Brooke Marshall  
Principal – Renewable Energy Assessments  
NGH Pty Ltd  
Suite 11, 89-91 Auckland Street  
Bega NSW 2550

Ref: 167  
21 October 2022

### Blind Creek Solar Farm – Response to Agency Comments

**Table 1: Agency Comments and Response**

CLIENT: **BLIND CREEK SOLAR FARM**  
TITLE: **114 CURRANDOOLEY ROAD BUNGENDORE**  
**LOT 1 DP 1154765**  
**ENTRANCE DESIGN**  
**PLAN VIEW**

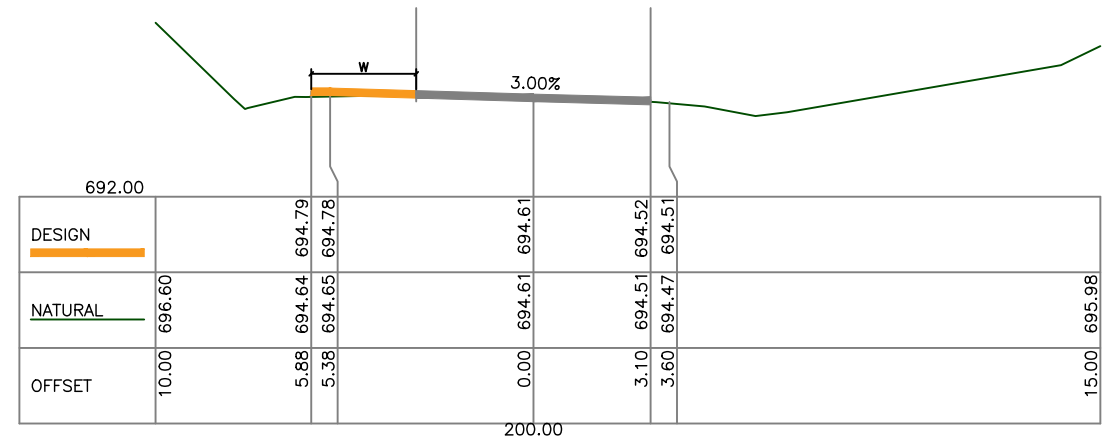
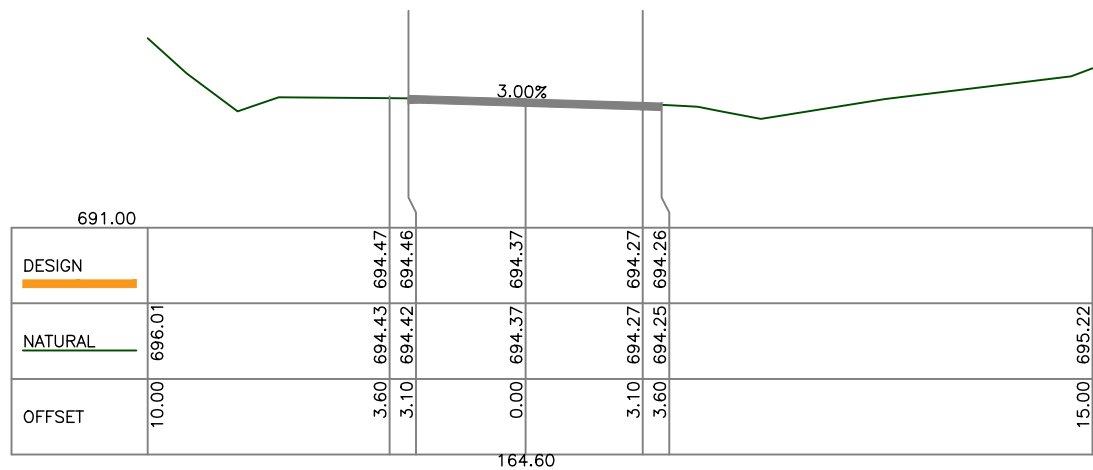
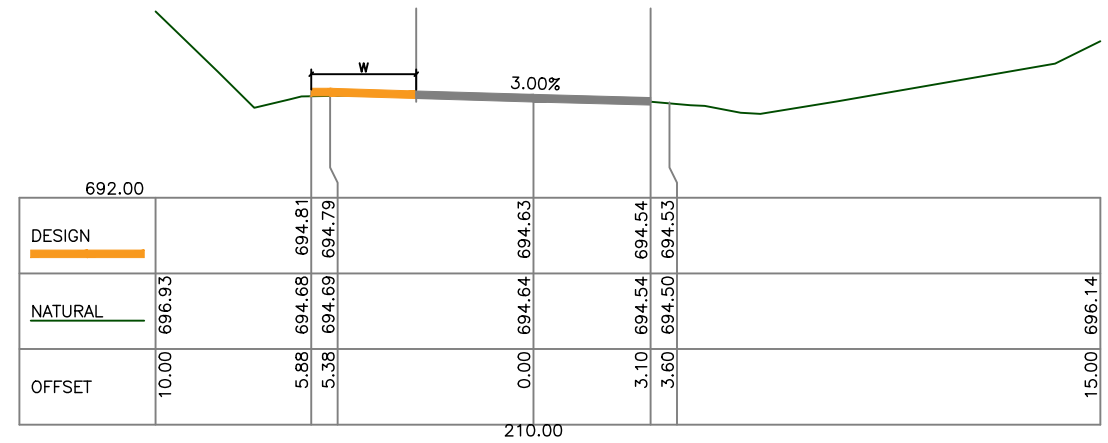
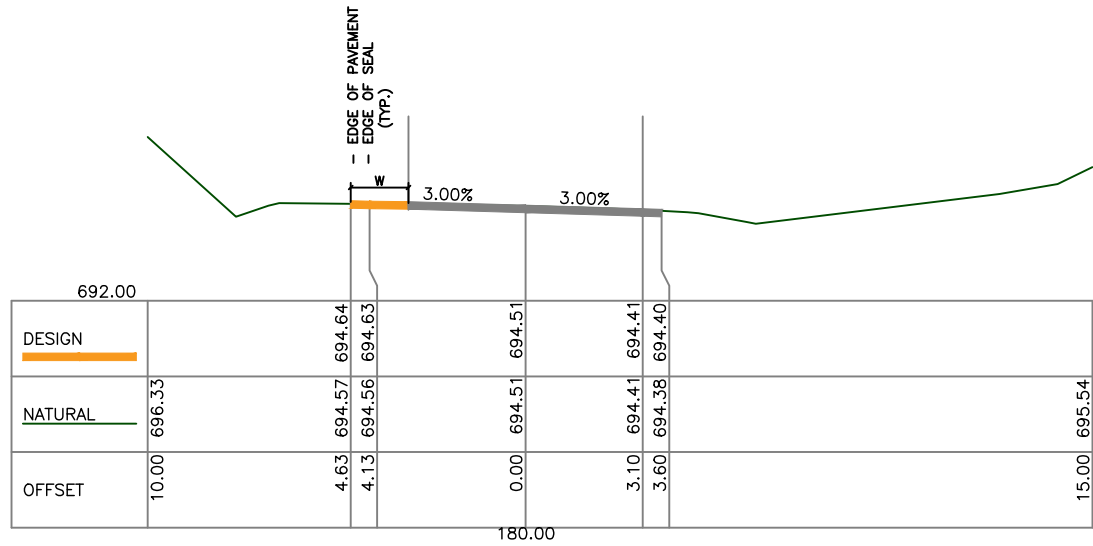
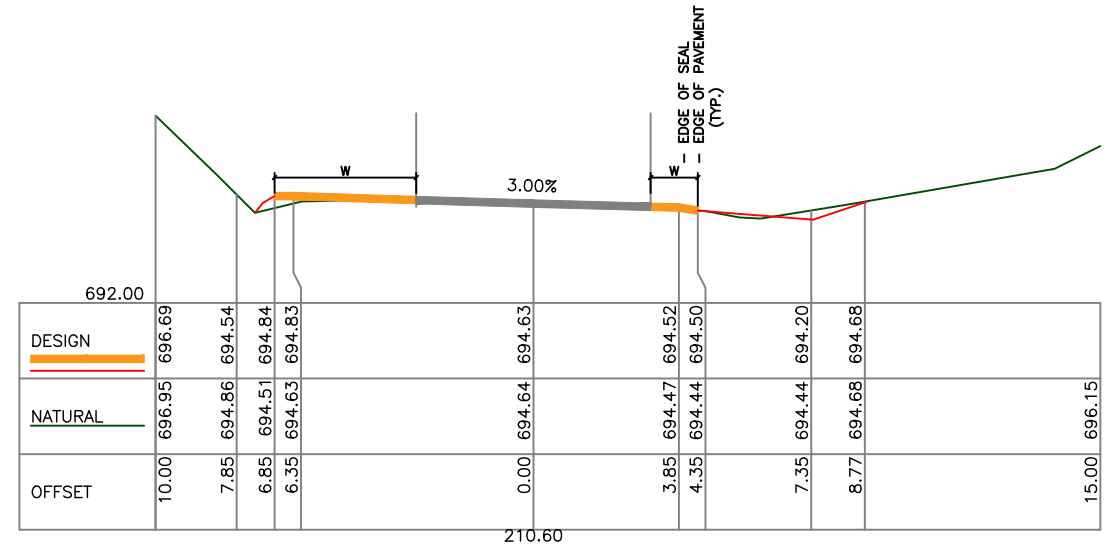
Comment	Response
Transport for NSW	
The length of the BAR treatment should be extended to comply with Figure A 28 of Austroads Guide to Road Design Part 4. The length for the turning path (X) should be added and the tapers should be designed for a design speed of 110kph.	Detailed design drawings for the site access have been prepared by PHL Surveyors. The design shows a BAR treatment in accordance with the Austroads Guide. The detailed design drawings have been provided within Appendix A.
The table drains on both sides of Tarago Road will have to be reinstated. Cross sections will be required to confirm the roadworks can be contained within the road reserve.	The detailed design plans are understood to have addressed this matter.
TfNSW notes only the section shown in Attachment 3 is approved as a B-double route but the intention is to use B-doubles during construction and deliveries. Clarification is required as to how the applicant intends to utilise B-doubles noting the above.	The use of sections of road that are not rated to accommodate B-Doubles is typically subject to specific permit application process that occurs following approval of the planning permit. As such, it is understood that this matter will be addressed prior to construction as part of the permit process.

FIGURE A28

X=15m (TURNING VALUE)

S=20m (STORAGE)

V=110kph (SPEED)

F=3.4m (WIDENING)

$$A = \frac{0.5 \times 110 \times 3.4}{3.6} = 52\text{m (say 54m)}$$
